UNITED STATES PATENT AND TRADEMARK OFFICE

APPLICATION NO.	FILING DATE	FIRST NAMED INVENTOR	ATTORNEY DOCKET NO.	CONFIRMATION NO.
10/541,294	06/30/2005	James M Milliken	248.03	6643
37761 7590 10/18/2007 ERICKSON & KLEYPAS, L.L.C. 800 W. 47TH STREET, SUITE 401 KANSAS CITY, MO 64112			EXAMINER HAYES, KRISTEN C	
			ART UNIT 3643	PAPER NUMBER
			MAIL DATE 10/18/2007	DELIVERY MODE PAPER

Office Action Summary

DETAILED ACTION

Modified Figure 5, US Patent 5,709,049

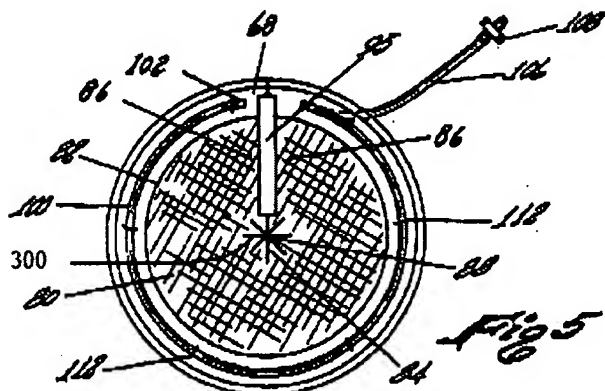
19. Regarding claim 19, Baird discloses a device with the limitations of claim 19 further characterized by the openings (88 or 301) being partially defined by respective portions of the tube (100 or 200) (Baird, Figure: 5).

Modified Figure 12, US Patent 5,709,049

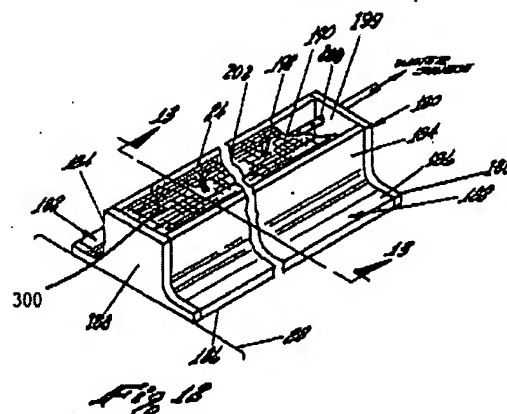
8. Regarding claim 1, Baird discloses a garden weed barrier and watering apparatus (20 or 180) comprising a flexible sheet (80 or 190) of vapor-permeable material (Baird, column 2: lines 1-2), said sheet having reinforced outer edges (42 or 184, 186)(Baird, column 4: lines 7-9) and openings (Baird, Figure: 12) in said sheet for garden plant (24) stems to extend therethrough; means for weighting said edges to secure said sheet to the ground (Baird, column 2: lines 4-7); and a fluid-permeable (104) tube (100 or 200) secured to a lower surface of said sheet for delivering fluid to ground proximate to garden plants (Baird: column 8, lines 21-24).

18. Regarding claim 17, Baird discloses a device with the limitations of claim 16 further characterized by the tube (100 or 200) having segments thereof attached in close proximity to corresponding openings (Baird, Figure: 12).
